Consultation response form

Consultation title	Amazon Kuiper UK Limited application for a non-geostationary gateway earth station licence
Full name	[REDACTED]
Contact phone number	[REDACTED]
Representing (delete as appropriate)	
Organisation name	Viasat, Inc.
Email address	[REDACTED]

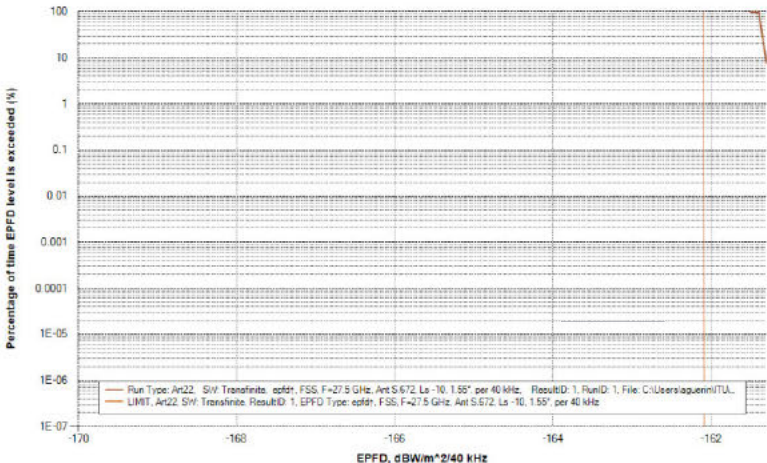
Question	Your response
	unavailability increase criteria, these methodologies certainly have not been established as “suitable” for evaluating impact of interference. ITU-R Recommendation S.2131, which is referenced by Amazon in their additional information document, sets forth a method for determining performance objectives for satellite hypothetical reference digital paths utilizing ACM. This recommendation defines the average loss in throughput with the following formula: $\text{Throughput} = \text{Channel rate} \times \text{Time}$ $\text{Lost throughput} = \text{Maximum available throughput} - \text{Delivered throughput}$ $\% \text{ degraded throughput} = (\text{Lost throughput} / \text{maximum available throughput}) \times 100$ Critically, however, this recommendation does not specify the time period over which this criterion should be computed, which is addressed in Note 4 of the ITU-R Recommendation S.2131. Note 4 states that the time-average throughput over any year does not provide sufficient information on link performance for specific time percentages for any given time period during the year. Additional performance requirements in terms of throughput/spectral efficiency, as a function of the year’s percentage, also need to be considered in the overall performance assessment of links using ACM, warranting further studies. In addition, Resolution 769 (WRC-19) also calls for further studies on the selection and use of C/N objectives, and the necessity of specifying one or more C/N objective points at associated percentages of time, with regard to the GSO link performance. Clearly, the annual average throughput criteria should not be the sole determinant for assessing NGSO emissions impact on NGSO or GSO link performance. Several key contributions have been submitted to the ITU, particularly at Working Party 4A, aiming to highlight and address these concerns. Notably: • Document 4A/270⁵, assessing the impact of non-GSO systems on GSO networks using average throughput degradation criteria, demonstrates that long-term interference significantly impacts Ka-band GSO networks.

Question	Your response
	The degradation in spectral efficiency, with and without ACM, indicates that using this type of criterion is inadequate for protecting GSO networks from prolonged non-GSO interference. Document 4A/826⁶ (WRC-19 cycle) presents an example where an FSS link using ACM, factoring in average degradation in spectral efficiency, shows a 1.86% degradation, within the 3% single-entry limit. Certain periods during the year, however, see degradation in spectral efficiency exceeding 23%, far surpassing the acceptable 3% threshold for 99% of the year. These studies unequivocally indicate that the annual average throughput degradation criteria defined in the ITU Radio Regulations No. 22.5K and 22.5L fails to appropriately and reliably assess the impact of NGSO systems on GSO networks or NGSO systems. A more comprehensive assessment method, taking into account more granular time-specific impacts, is imperative to ensure appropriate coexistence between NGSO systems and to limit long-term NGSO system interference. On previous occasions, Ofcom has clarified that their NGSO licensing requirements are developed to reinforce ITU process and methodologies rather than replacing them with different criteria on a national basis. In the case of the short-term impact of Amazon's NGSO system, there have been no studies conducted on the absolute unavailability degradation methodology in the ITU. Rather, proposals on this methodology have been either opposed outright at ITU Working Party 4A or invited calls for studies⁷ on the basis that it does not adequately protect the interference recipient system and caps its availability performance with no room for further improvements. Implementing this approach would almost certainly result in frequent outages and a degraded user experience for GSO networks, irrespective of their architectural design. Resolution 770 and No. 22.5L of the ITU Radio Regulations provide <i>relative</i> degradation to unavailability as a criteria to assess short-term interference impact from NGSO systems. If Ofcom wishes to deviate from ITU standards, then we urge Ofcom to conduct its own independent assessment of the new "absolute" unavailability criteria on both single-entry and aggregate basis and how it could impact both GSO networks and NGSO systems.
